BRITISH-GLIDING-ASSOCIATION

TECH. COMMITTEE, TNS 4,5,79.

Airworthiness Directive

LBA Airworthiness Directive AD-Note no. 78 -

13. PASSENGER WALKED INTO PROPELLER

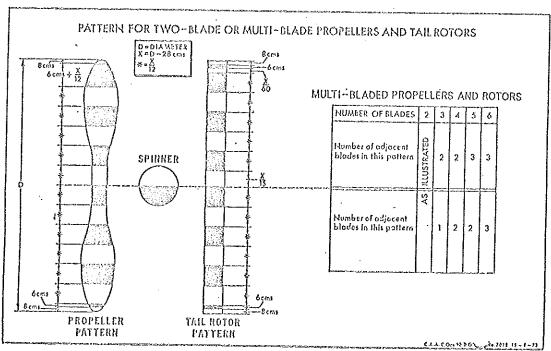
A recent fatal accident involved a passenger who walked into a propeller while the engines were running. A survey of UK accidents of this type shows that a total of 24 occurred between 1962 and the present time; 12 of these were fatal, 5 on single-engined aircraft and 7 on multi-engined aircraft.

Blades to be painted: A propeller which is outside the pilot's field of vision when he looks ahead should be painted on both sides and the spinner painted as illustrated. Blade surfaces within the pilot's field of vision ahead should not be painted and any spinner similarly located should be painted completely in white.

Colours: Markings should be in black and white.

Painting: The finish should be gloss. Aircraft owners should consult the aircraft manufacturer in cases where no specific information is available as to what types of paint may be used on propeller or rotor surfaces.
